Drawing No	21111393_01
Revision	B
CD number	49
Date	01/08/00
Department	Sales Support
Contact name	Roger Spoons
Client	Starbucks
Subject	60-61 Hampstead High St.

DOMING SIGNS

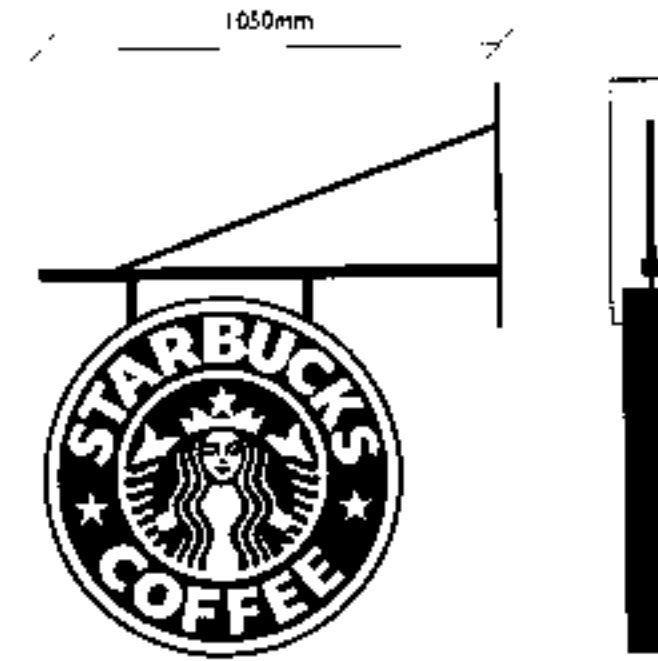
Rev 3 - A.H. 01/08/00
Add cover change lighting from cond lamps to Cyber 2 spotlights.
Revol - A.H. 17/08/00
Remove hanging signs and add projecting sign on LHS, plus awns.
